37/3-00AA 238 Park Avenue (Takoma Park Historic District)

HISTORIC PRESERVATION COMMISSION STAFF REPORT

PROPOSAL: Replace original stucco siding

PROPOSAL: Rear alterations to adapt house from apartments to single family occupancy

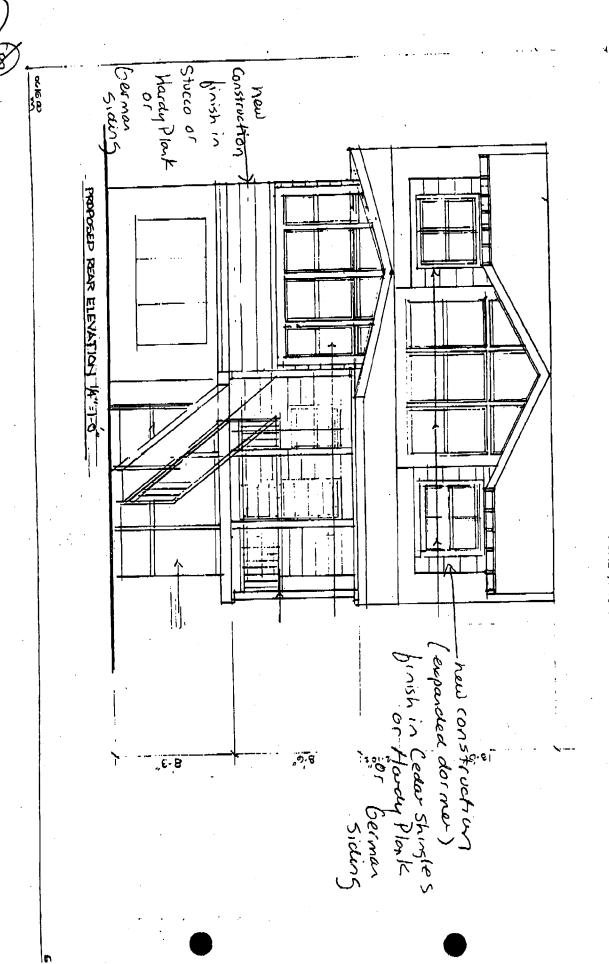
Therefore, we'd like to request approval to use any of the following materials on the new construction: 1) stucco; 2) HardyPlank concrete plank siding with a 7 ½ inch reveal; 3) "German" siding, or 4) Cedar shake shingles.

4) Siding or shingles on the upper half or third of the house (see drawing), contrasted with stucco on the first floor.

1) The asbestos shingle siding may be removed, but replaced only with a stucco finish that matches the original stucco finish.

ALTERNATIVE SECOND STORY

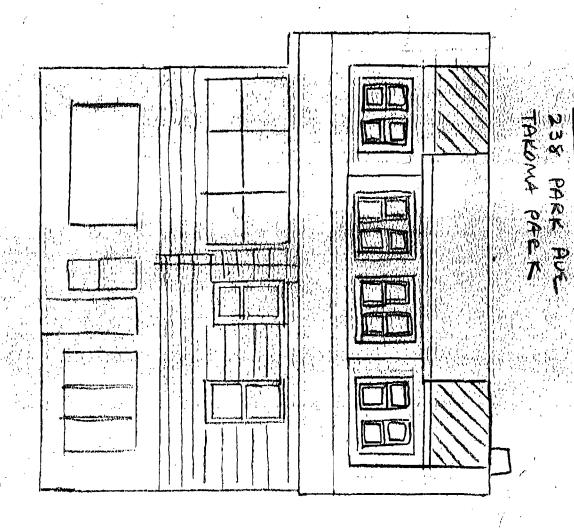
I am writing regarding our proposal for renovation of the house at 238 Park Avenue in Takoma Park. In addition to asking the Commission to approve the plans as initially submitted, we would also ask approval for an alternative, "scaled-back" plan, as shown on the drawing labeled "Alternative."

This alternative would simply extend the existing rear second-floor dormer the full width of the house, but preserve the existing second-story roofline by maintaining a "shed" rood rather than adding the new "gable roof." There would be no fixed windows in this plan, but simply double-hung sash windows consistent in size and appearance with the rest of the house.

3. Alternative of proposal would also be ox.
